## IBC – GENERAL

Code Change No: **G6-07/08**

**Sections: 106.1; IFC 105.4.1; IRC R106.1; IEBC 106.1**

Figure 1. Bumper Load Application

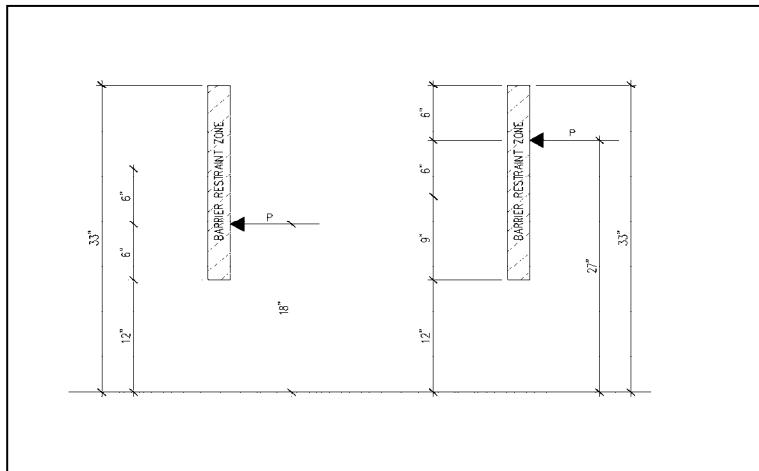
In addition to revising the bumper height used in designing barrier restraints for parking structures, the applied load may also need to be revised. Light trucks and SUV's are heavier than the typical automobile. The empty weight of a Lincoln Navigator, a large sport utility vehicle (SUV), is approximately 7,000 pounds. Some large pick-up trucks have gross (loaded) weights of up to 10,000 pounds.

Also, the speed at point of impact may have to be reconsidered. At least one of the failure incidents reported a speed of 10 to 14 mph compared to a speed of 5 mph used to determine the current load requirement.

Finally, the design methodology may have to be revised. The key to vehicle impact restraint design is to absorb and dissipate the kinetic energy created by the moving vehicle impacting the barrier. The kinetic energy is created by a combination of the vehicle speed or velocity and the vehicle weight where  $KE=1/2mv^2$ .

**FIGURE 1 – 408.5.3 Item 3**  
**MULTILEVEL RESIDENTIAL HOUSING WITHOUT**  
**VERTICAL OPENING ENCLOSURE**

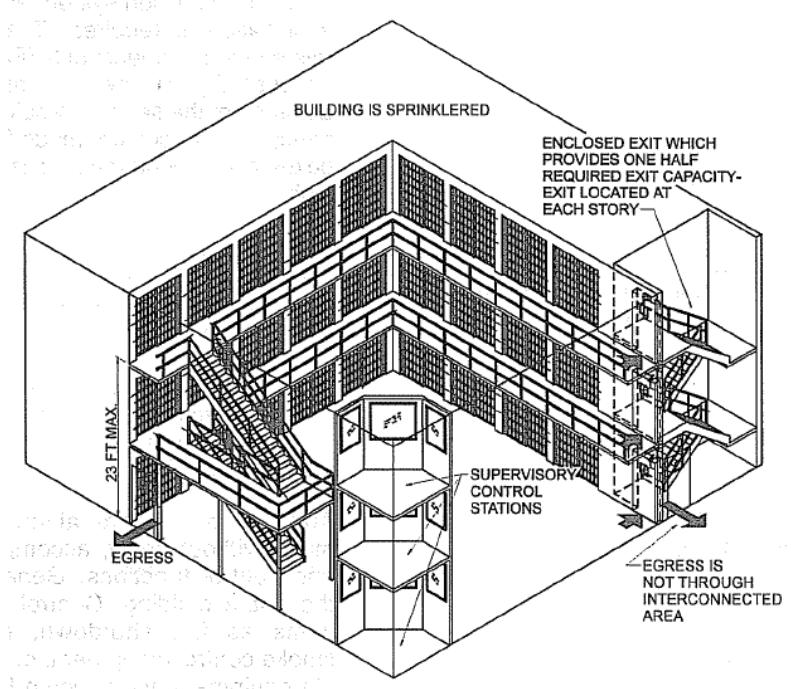
**Reason:** This change is intended to clarify the exiting from floor levels within the residential housing units. Without this change the “floor levels” get treated as stories and additional exits are required. Currently a residential housing unit with two floor levels and a very small occupant load can be required to have three exits which in a detention facility is problematic. This change would then allow the two level units to have just two exits with no direct egress from the upper floor level as long as common path and travel distances are met. The figures below illustrate the proposal and should be included in the commentary.

## Section: 3002.4

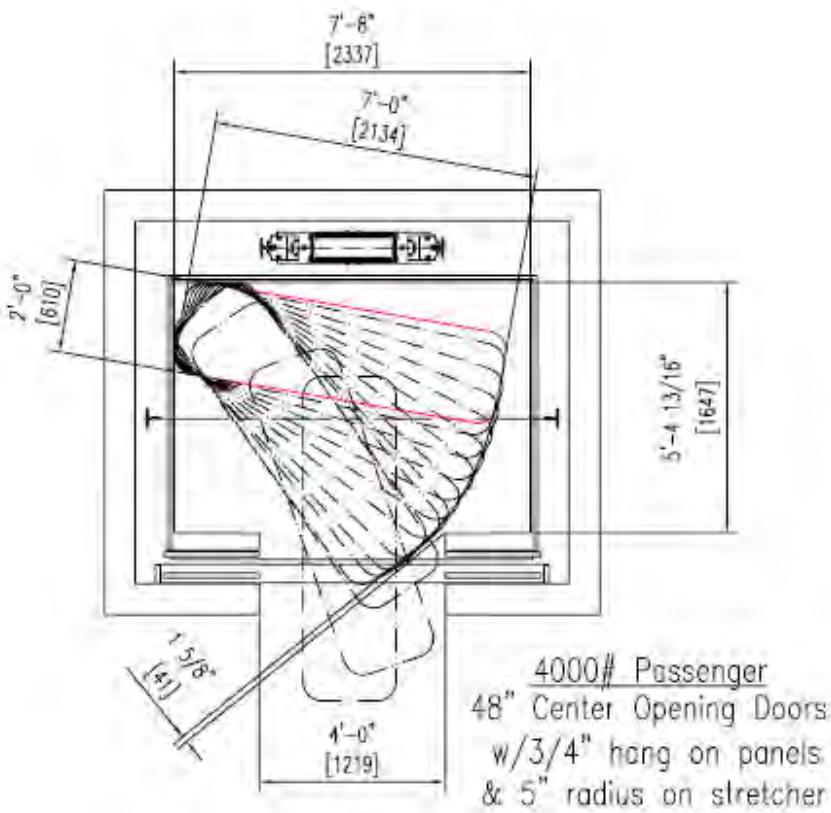
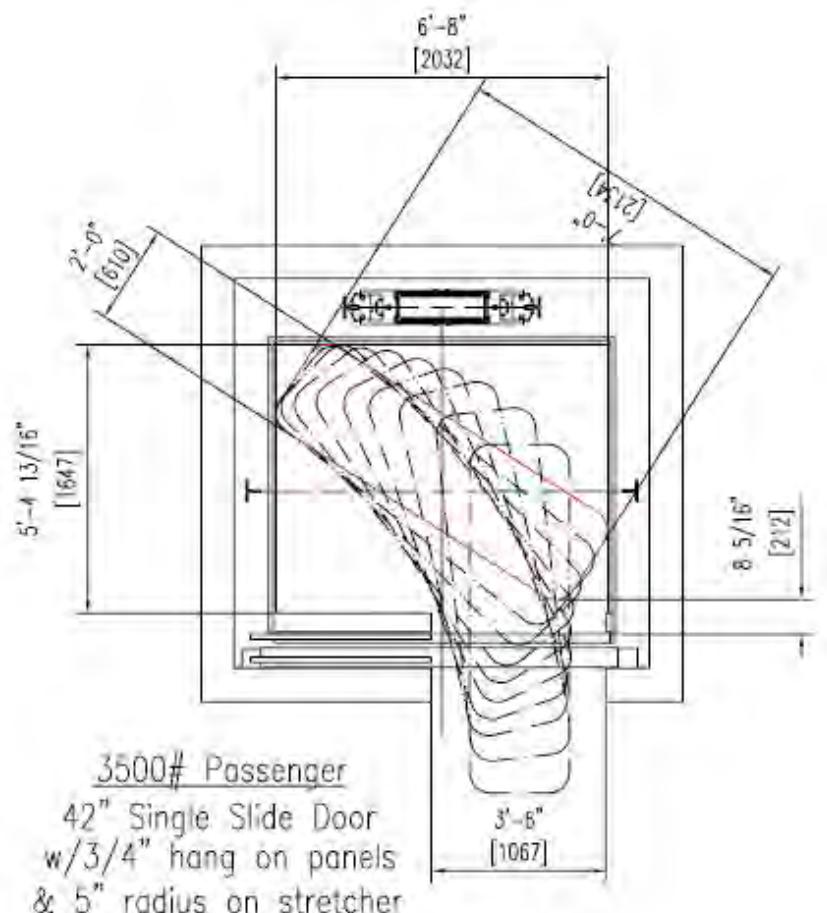
**Reason:** All ambulance stretchers found to date, are made from tubular metal, formed with radius or chamfered corners. Adding this change reflects actual stretcher size and will allow the industry to better meet the requirement with more flexibility and appropriately sized cars, while still meeting the size requirement desired by the IBC. This change will also have added benefit of providing direction to the stretcher suppliers to aid in standardizing their products. None of the vendors researched to date offer a 24 inch by 84 inch ambulance stretcher, Stryker, the largest stretcher manufacturer, has a standard stretcher of 23 inches by 83 inches, with a combination of radius and chamfered corners. Further the only standard for ambulance stretchers found was a European Specification, EN 1865:2000. Section 4.1.5 Frame states "All corners of the frame shall be radiused for greater safety."

**3002.4 (Supp) Elevator car to accommodate ambulance stretcher.** Where elevators are provided in buildings four or more stories above grade plane or four or more stories below grade plane, at least one elevator shall be provided for fire department emergency access to all floors. The elevator car shall be of such a size and arrangement to accommodate a 24-inch by 84-inch (610 mm by 2134 mm) with not less than 5 inch (127mm) radius corners, ambulance stretcher in the horizontal, open position and shall be identified by the international symbol for emergency medical services (star of life). The symbol shall not be less than 3 inches (76 mm) high and shall be placed inside on both sides of the hoistway door frame.
